RE: **Lot 2 Block 1 Unit 5 SAD 227
6605 Rim Rock Cir. NW
Volcano Cliffs Subdivision
Grading and Drainage Plan
Engineers Stamp Date 3/22/2024 (D10D026)**

Based upon the information provided in your submittal received 3/25/2024, this plan is approved for Grading Permit.

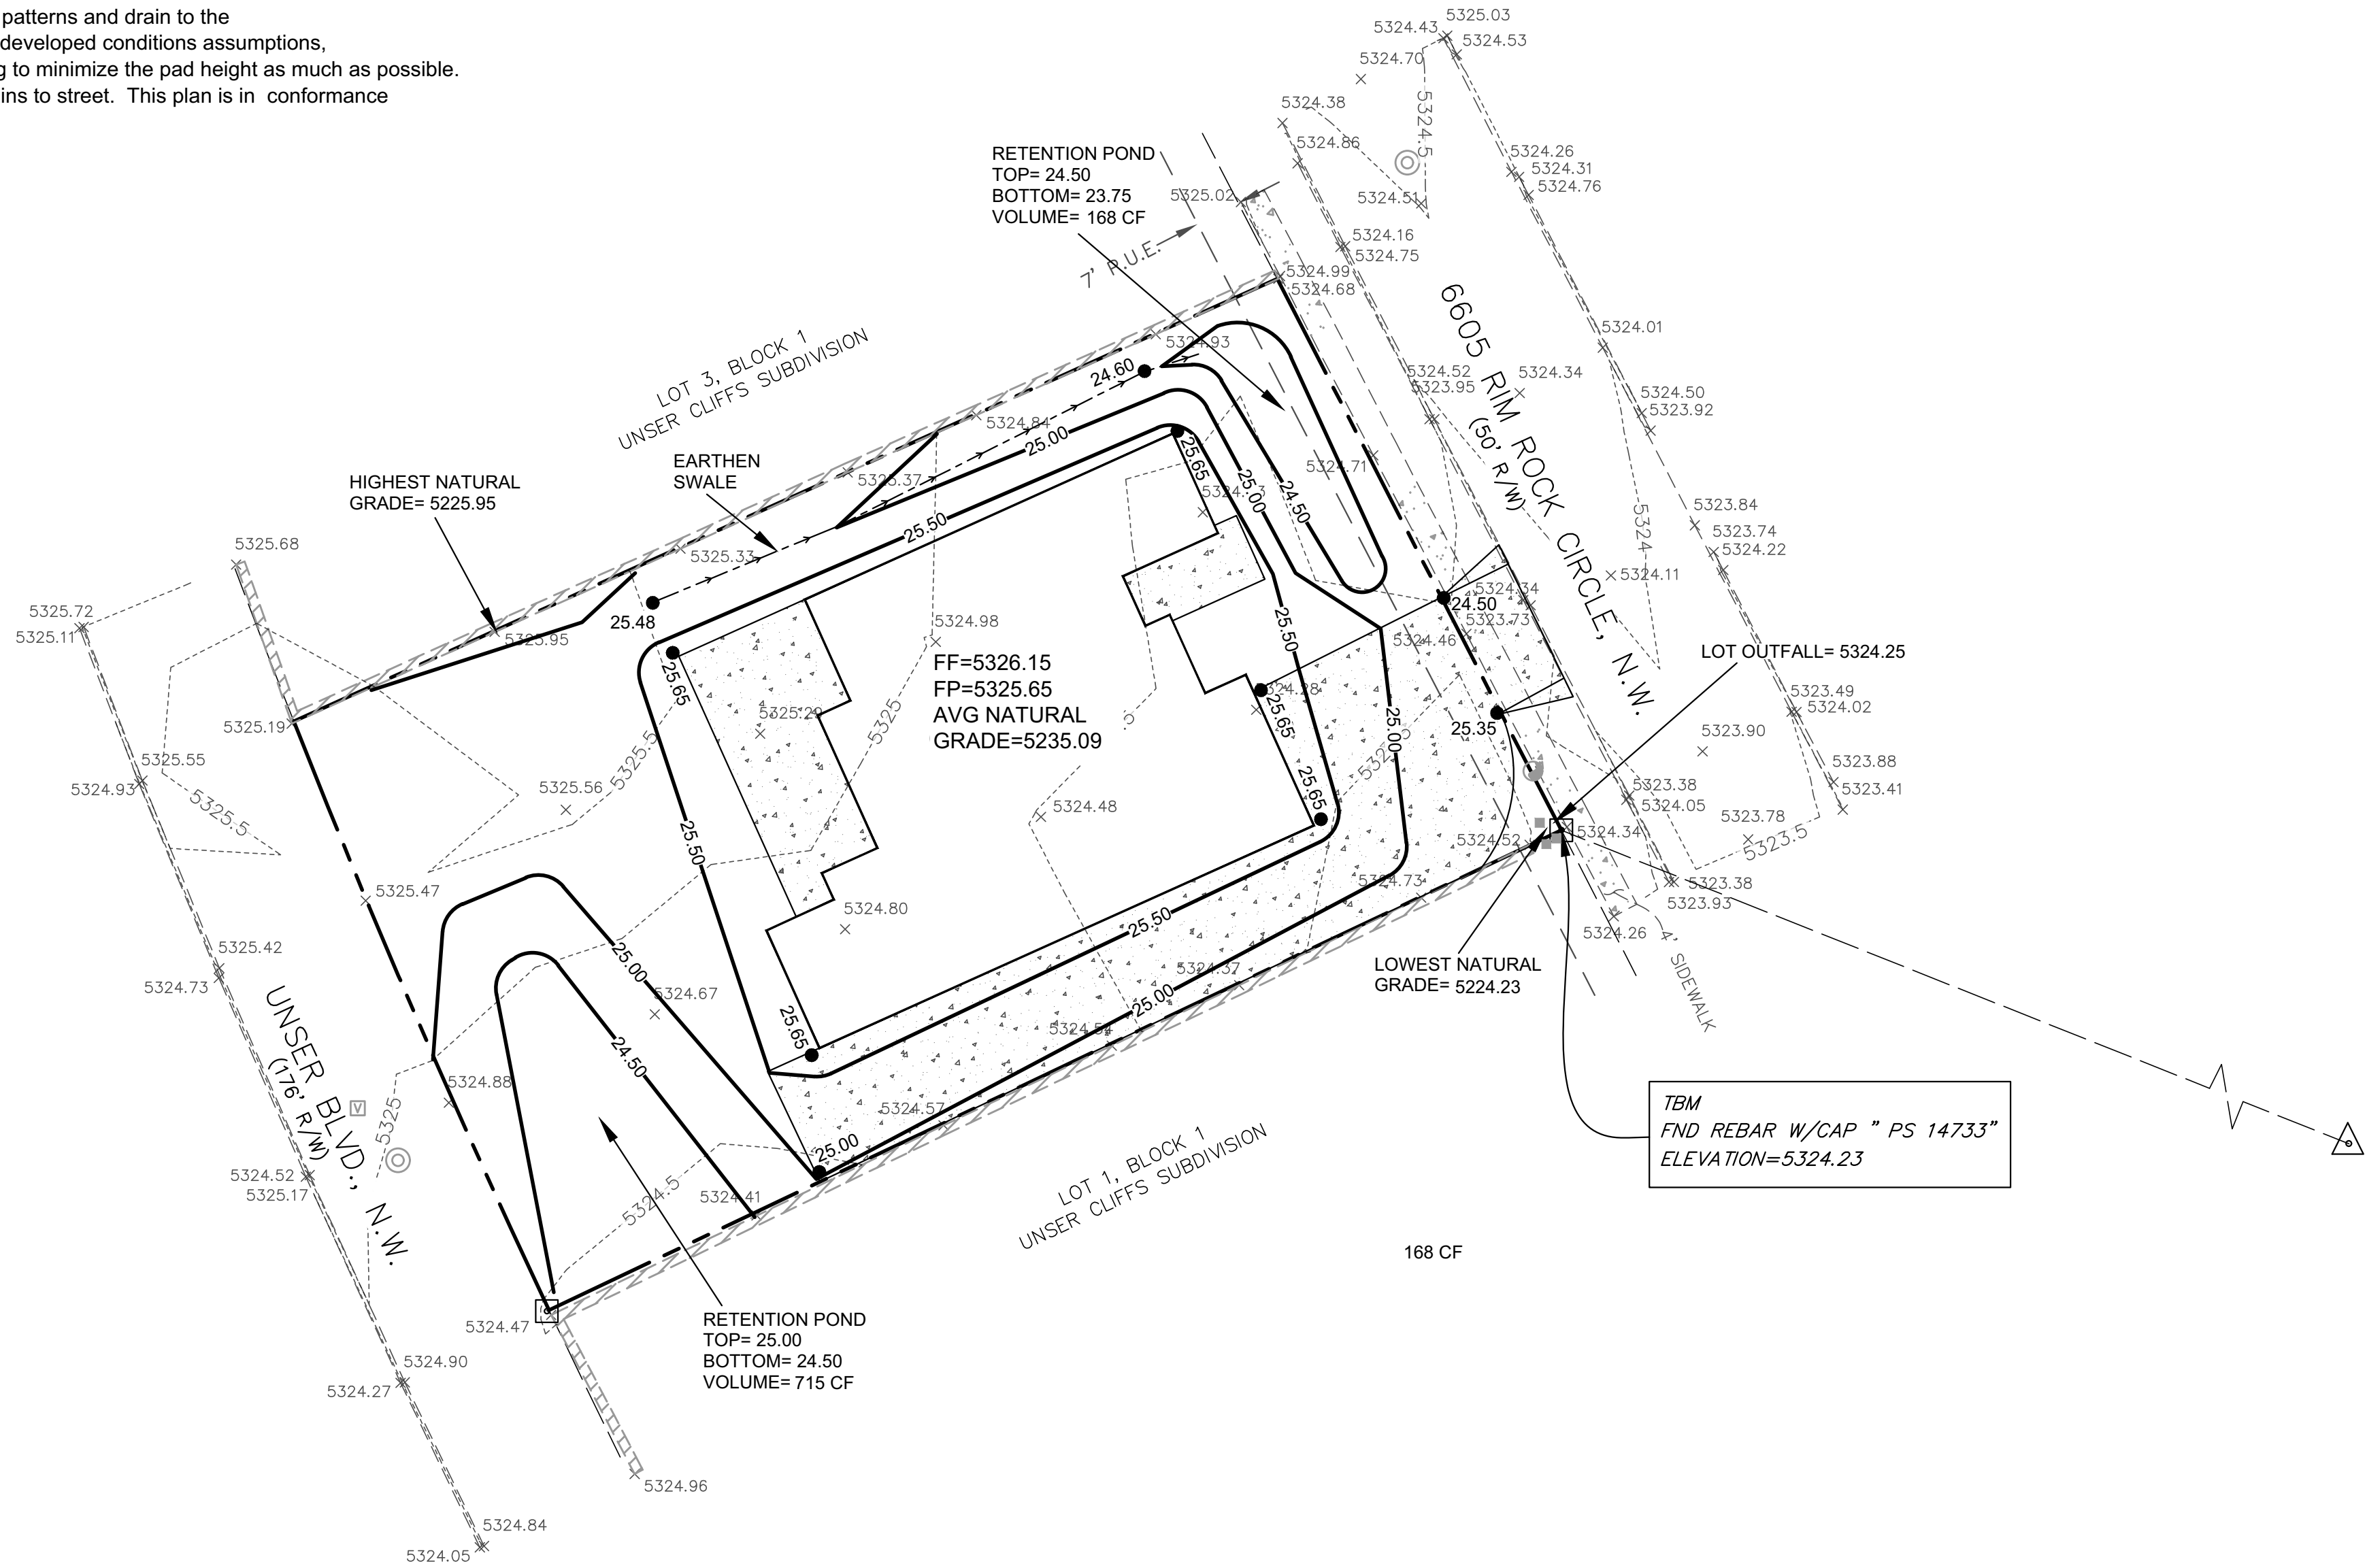
Advise the owner contractor not to use dirt as a ramp to climb the curb, use lumber or crusher fines for this purpose. Place this note on the plan.

Reiterate to the Owner/Contractor that a separate permit for a garden/retaining wall must be obtained with the approved G&D plan and Pad Certification. Also, if a swimming pool is to be placed after this approval a new grading and drainage plan will need to be resubmitted showing the changes for the land treatments.
